Office Action Summary

10/506,295

BATTERY PACKAGE AND METHOD OF CHARGING AND DISCHARGING THE SAME
Takuma IIDA, et al; SN. 10/506,295
Replacement Sheet

FIG. 1

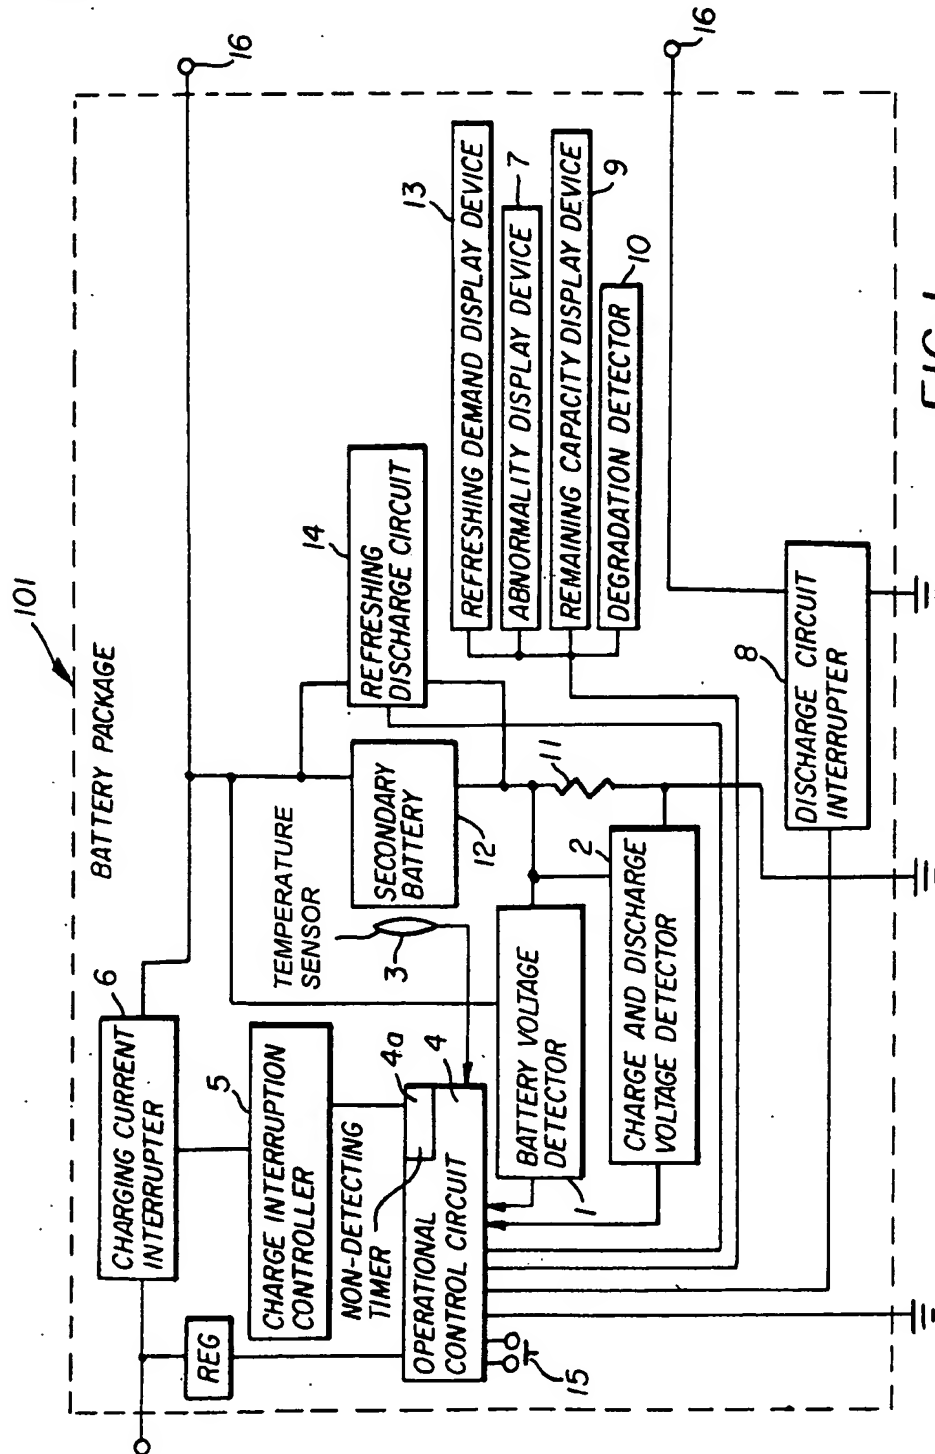
1. The specification has not been checked to the extent necessary to determine the presence of all possible minor errors. Applicant's cooperation is requested in correcting any errors of which applicant may become aware in the specification. For example, element 4a shown in the replacement drawing is not described in the specification.
2. The specification is objected to as failing to provide proper antecedent basis for the claimed subject matter: "the secondary battery does not exceed a preset voltage". See 37 CFR 1.75(d)(1) and MPEP § 608.01(o). Correction is required.
